MEDIO CREEK WRC FILTER AND UV SYSTEM IMPROVEMENTS PROJECT

Solicitation Number: CO-00226

ADDENDUM 1

Date November 7, 2018

4 DETAIL
D-03

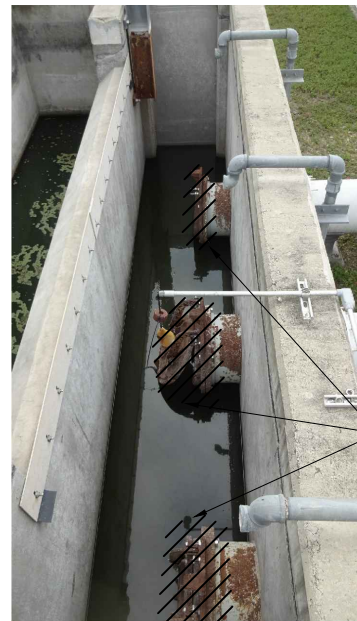
1. Sheet D-03, Replace the sheet with the attached.
 - a. Detail 4 - Updated to clarify that pipe supports are additionally to be removed.
2. Sheet M-04, Replace the sheet with the attached.
 - a. Details updated to include a second baffle wall as well as extension of the existing 6" MLSS return drain line through new grout fill.
3. Sheet I-03,
 - a. Modify tag for the 12 strand fiber between the Network Panel NET-15 and the Building 18 UV Control Panel to read "FOC-UV".
4. Sheet E-05,
 - a. On MCC-FLT One-line Diagram circuit 16, do not demolish (do not hatch) breaker. This will remain as a spare. Remove keynote 2, next to the circuit.

REMOVE EXISTING SPOOL PIECE (TYP. OF 3)
REMOVE EXISTING PIPE SUPPORTS (TYP. OF 3)

SHEET **M-04**
14 OF 67

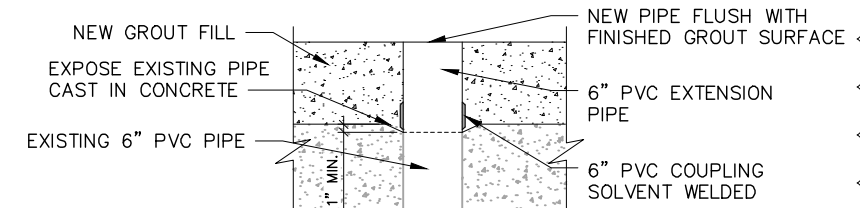
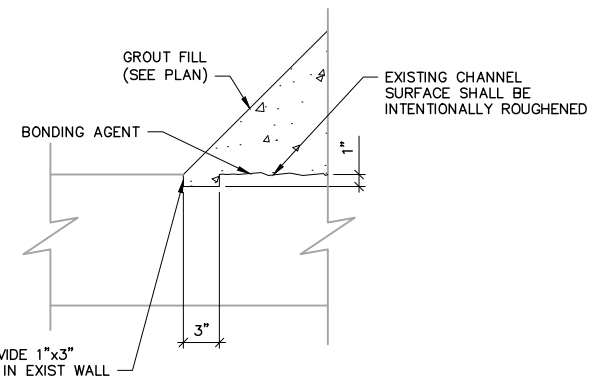
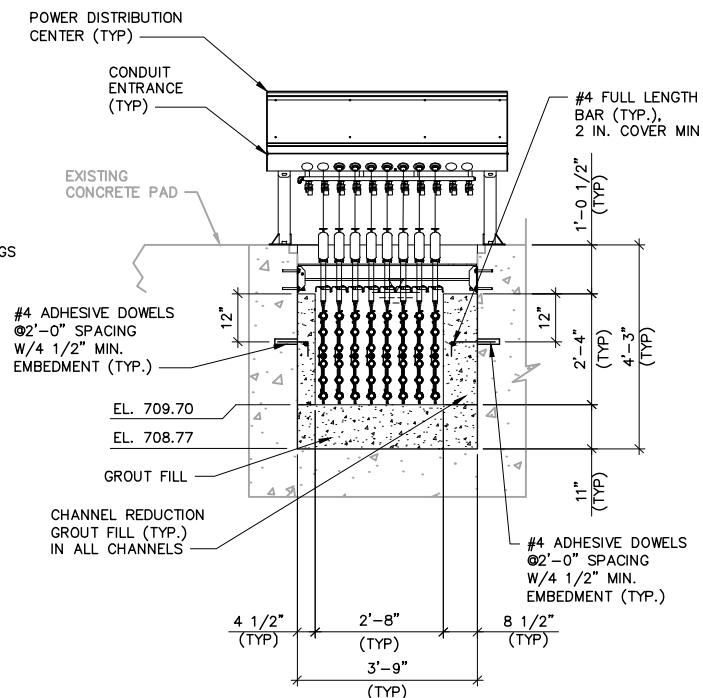
4. Drawing M-04: Please adjust the channel & water elevations as follows:

- Channel floor should be 709.70'
- Elevation post level control ramp should be 709.38'
- Channel Width for Banks should be 2'-8" and not 2'-8.5"

Response: See updated drawing M-04.

SHEET **E-13**
 53 OF 67

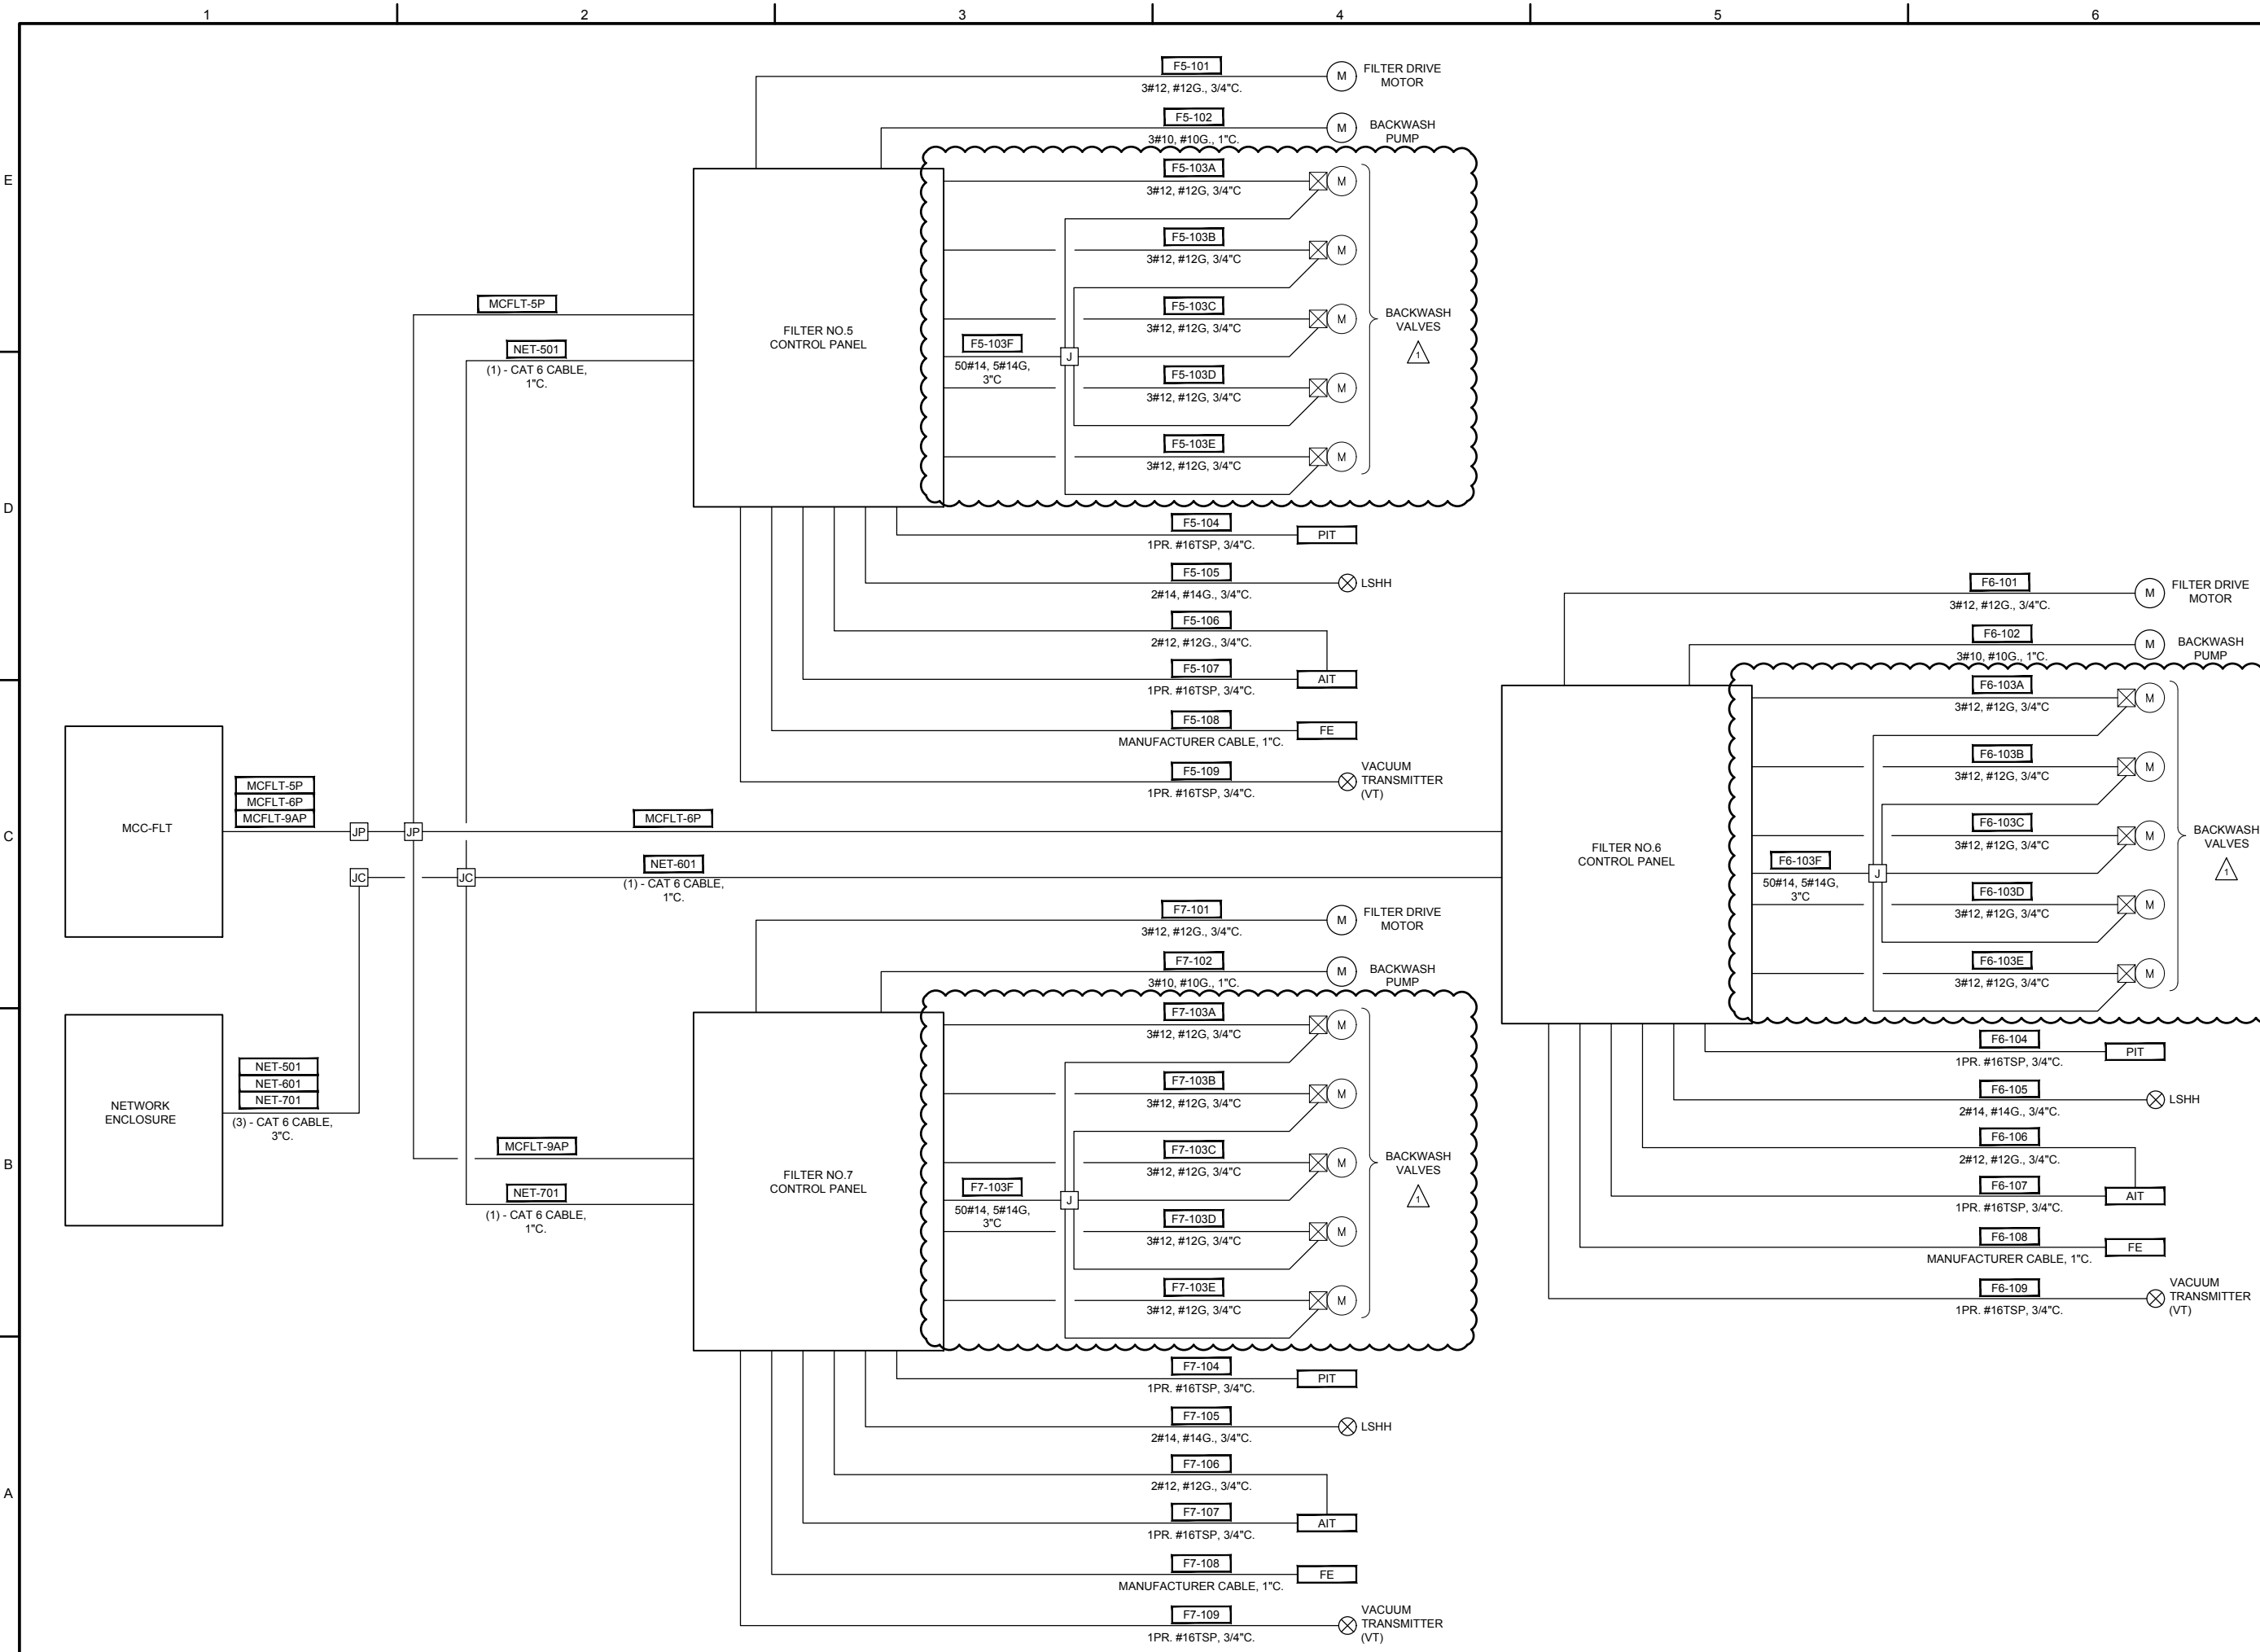
8. Sheet E-13, Replace the sheet with the attached.
 - a. Modified conduits from backwash valves to the Filter Control Panel. Added power conduit for each valve in addition to the controls conduit.

SHEET TITLE
ELECTRICAL
FILTER SYSTEM RISER DIAGRAM
SCALE: NONE
SHEET **E-14**
54 OF 67

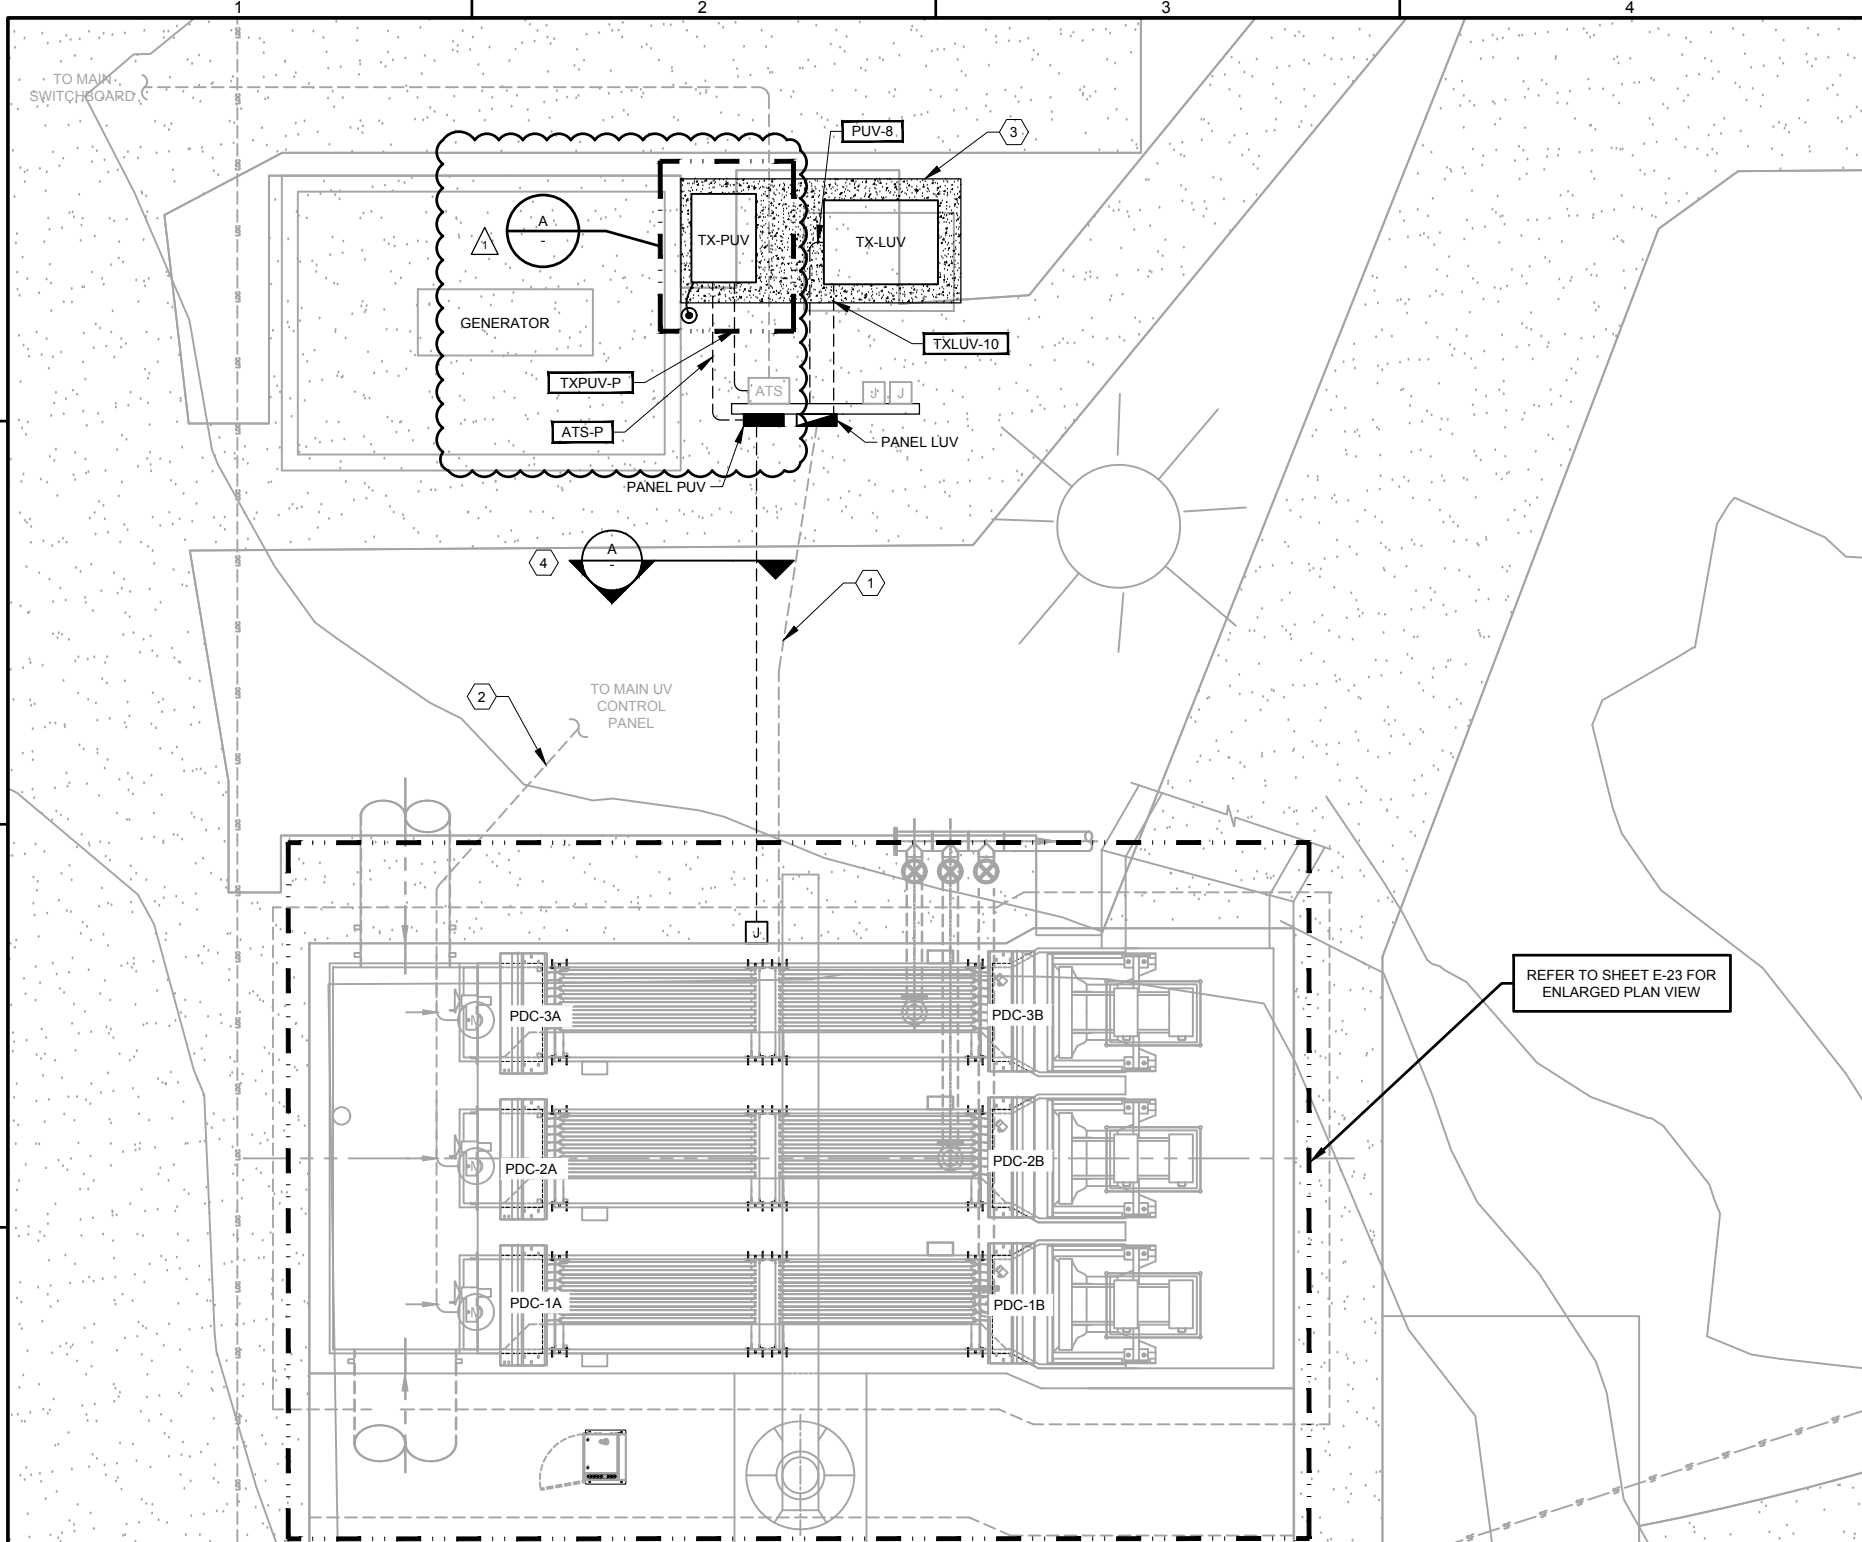
9. Sheet E-14, Replace the sheet with the attached.
 - a. Modified conduits from backwash valves to the Filter Control Panel (typical of all three filters). Added power conduit for each valve in addition to the controls conduit. Also increased control wire count for each valve.
